Naba Knit Composite Ltd.

15th APRIL 2014

Observations

Stress in concrete columns

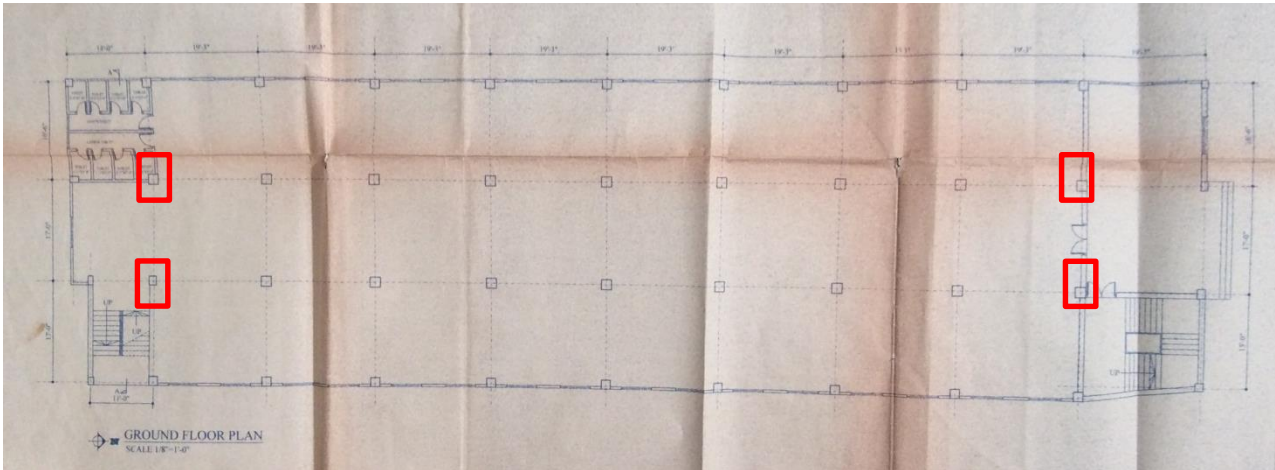
Areas with storage, masonry walls and increased floor finishes lead to significant axial stresses in columns.

Preliminary calculations show that finished garment storage and masonry walls around toilets lead to high column stresses in columns marked.

Concrete aggregate was observed as being brick at the ground floor.

The column capacity should be verified once the concrete strength in the identified columns has been confirmed at ground floor level.

Additional column at sixth floor level

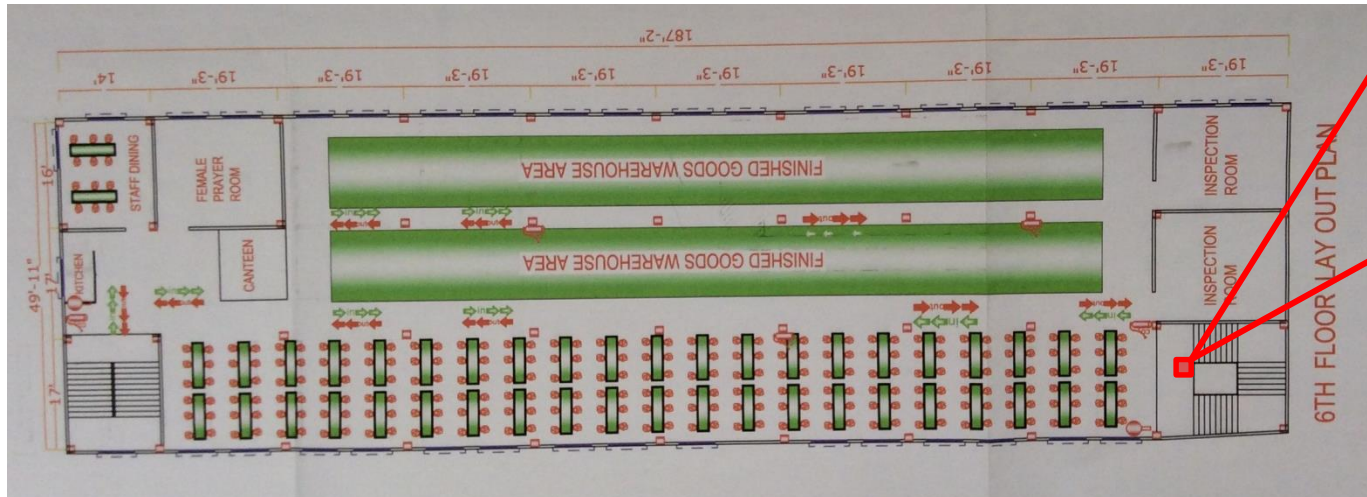
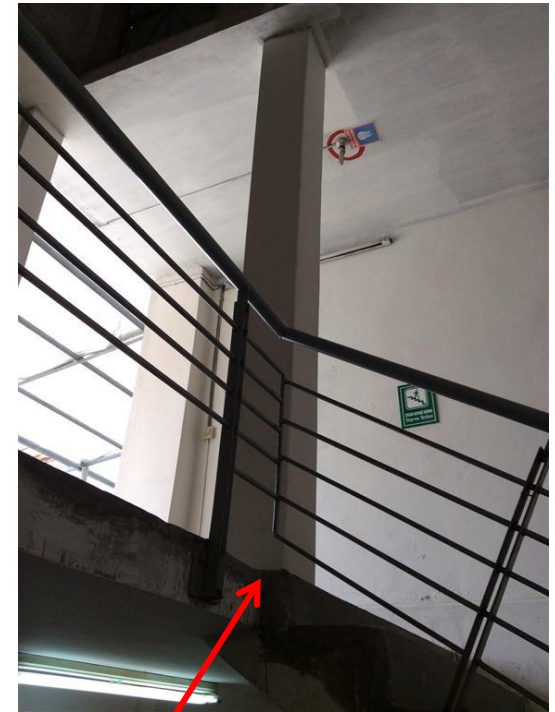
An additional column has been built between sixth floor and the roof over-run which is not shown on the layout drawings. This column is being supported by the stair landing at fifth floor only (no column below).

The column construction should be checked by removing the plaster finishes. The column design should be checked by the building engineer. The engineer should also confirm that the fifth floor slab is capable of supporting the column load.

Services cast through beams

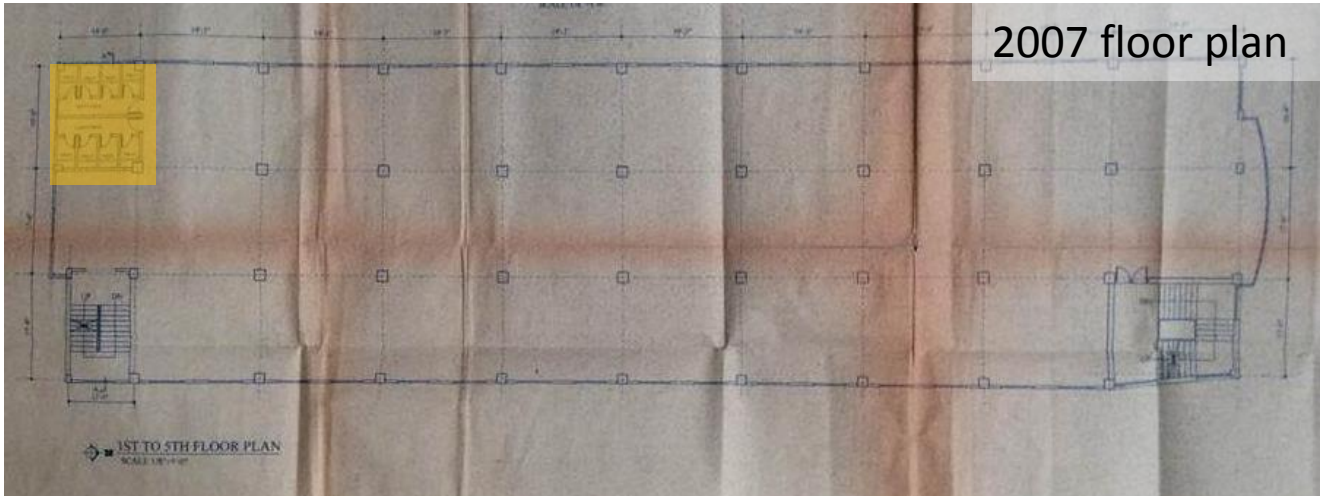
Conduits cast through third floor beam.

Building engineer to confirm that beam still has sufficient capacity for applied loads.

Conduit is not in use and could be grouted up.

Toilet locations

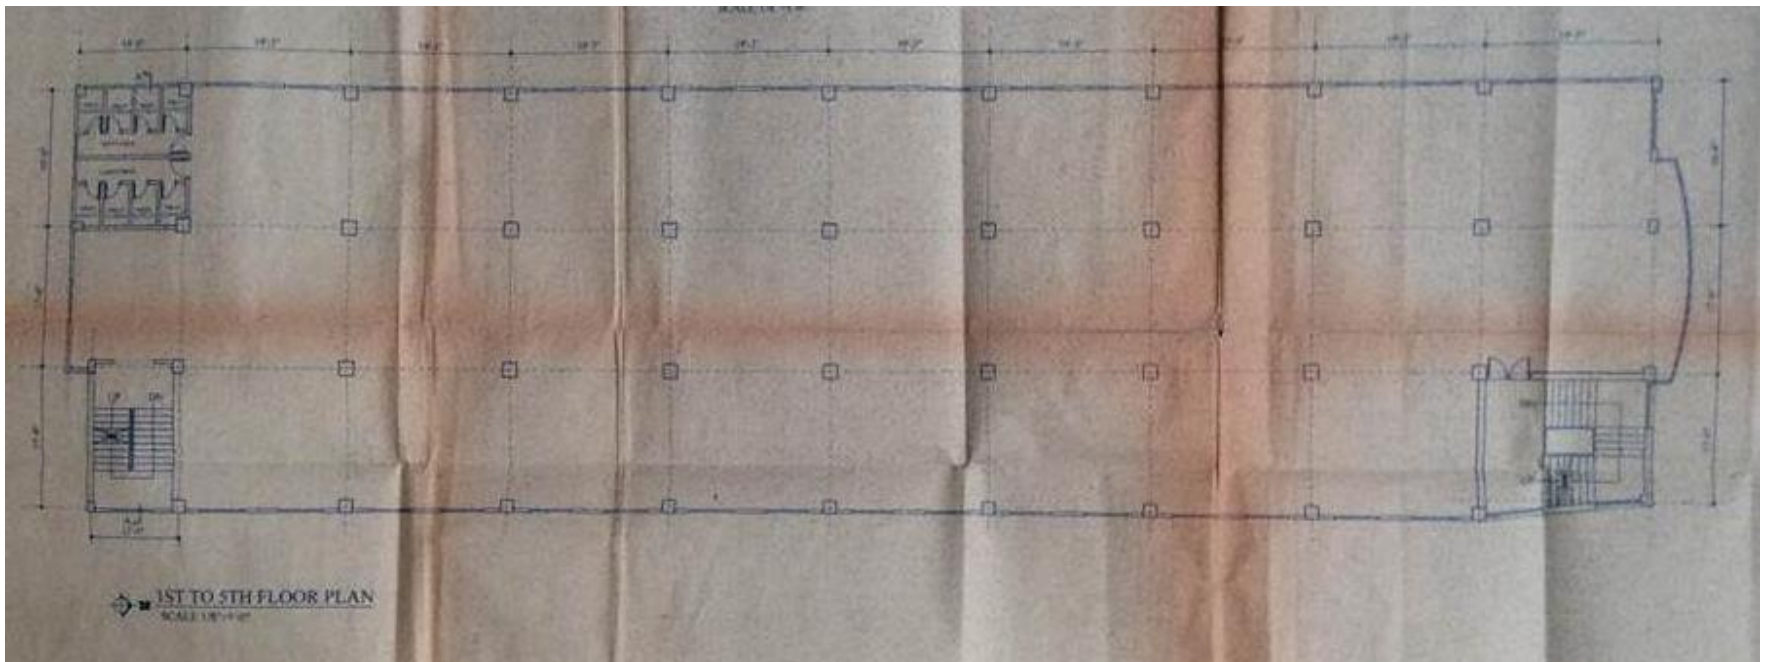
Toilets are located in a different position to that shown on layout drawings from 2007 (note that the location is shown correctly on recent factory layout drawings).

Building engineer to confirm that structure supporting toilets has been designed for increased finishes load and masonry walls.

Ground floor plan

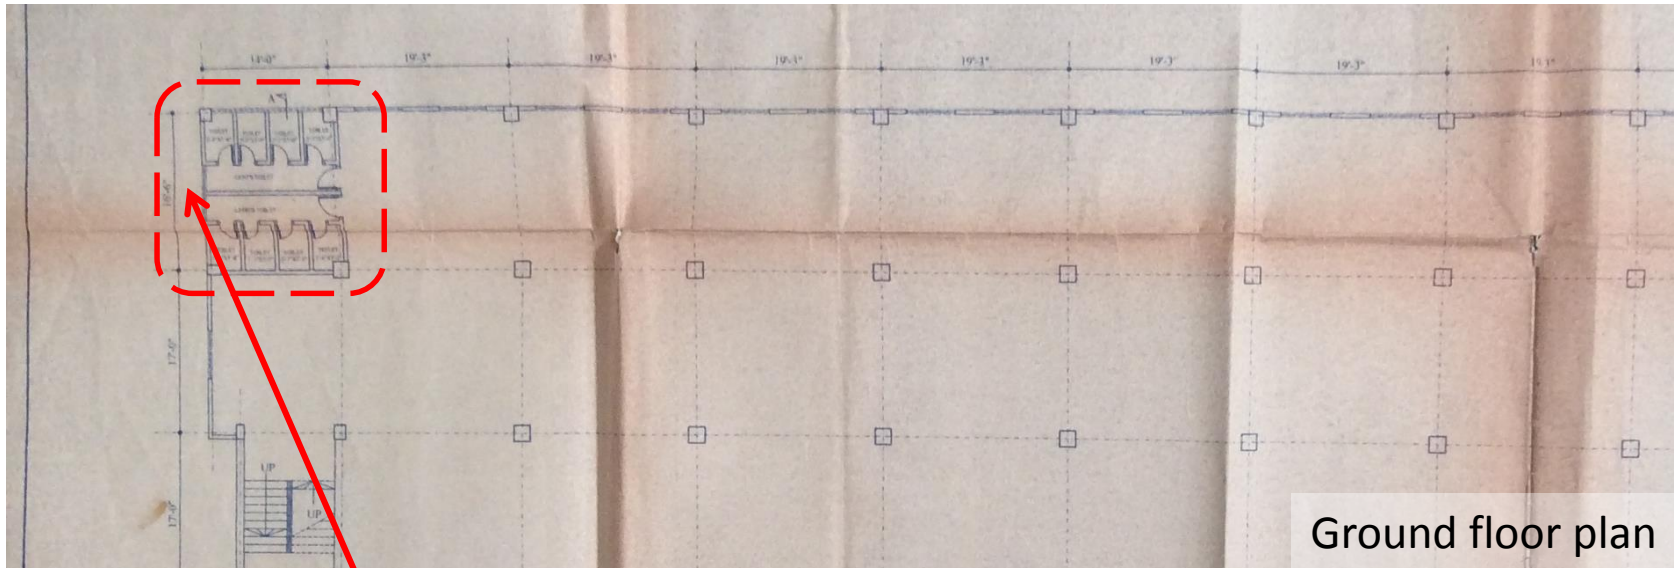
Structural drawings show total of 10x3 bays, frame constructed has 9x3 bays. Accurate as-built floor plans to be produced that reflect structural frame.
